Access Compliance Report

Public Rights-of-Way

(Curb Ramps)

Intersection ID: 10032380	Main Street: MT_HOLLY-HUNTERSVILLE_RD	Cross Street: N/A	Location: SE
ADA ID: 6635643341B6	Ramp Type: Perp	Initial Pass/Fail: Fail	Overall Compliance: No
Severity Score: 12.5			
Codes/Mitigation Info/Possible Solution		Field Measurements/Component Compliance

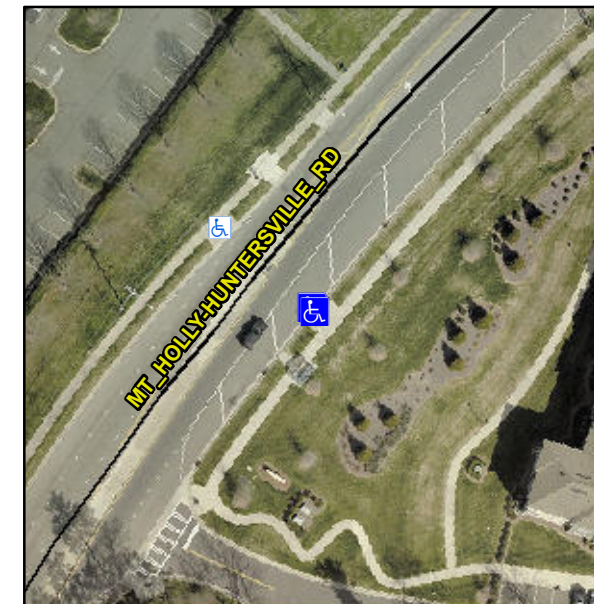
R304.2.2

Compliance	Description	Data	Compliance	Description	Data
N/A	Ramp Length (in)	97.0	No	Ramp Slope (%)	8.6
Yes	Ramp Width (in)	48.0	Yes	Ramp XSlope (%)	0.5
N/A	Flare Type LT	N/A	N/A	Flare Type RT	N/A
N/A	Flare Slope LT (%)	N/A	N/A	Flare Slope RT (%)	N/A
N/A	Flare Traversable LT?	N/A	N/A	Flare Traversable RT?	N/A
N/A	Landing Length (in)	N/A	N/A	DWS Provided?	N/A
N/A	Landing Width (in)	N/A	N/A	DWS Contrast?	N/A
N/A	Landing Slope (%)	N/A	N/A	DWS Length (in)	N/A
N/A	Landing X Slope (%)	N/A	N/A	DWS Full Width?	N/A
N/A	Landing Curb? (Y/N)	N/A	N/A	DWS Offset (in)	N/A
N/A	Shared Landing?	N/A			
N/A	Gutter Ponding?	Yes	N/A	Gutter Slope (%)	N/A
N/A	Gutter Lip Ht (in)	N/A	N/A	Gutter X Slope (%)	N/A
N/A	Painted X Walk1?	No	N/A	Painted X Walk2?	N/A
	X Walk 1 Direction	To NW		X Walk 2 Direction	N/A
N/A	X Walk 1 Width (in)	N/A	N/A	X Walk 2 Width (in)	N/A
	X Walk 1 Slope (%)	5.1		X Walk 2 Slope (%)	N/A
	X Walk 1 X Slope (%)	1.9		X Walk 2 X Slope (%)	N/A

Remove & Replace Entire Ramp.
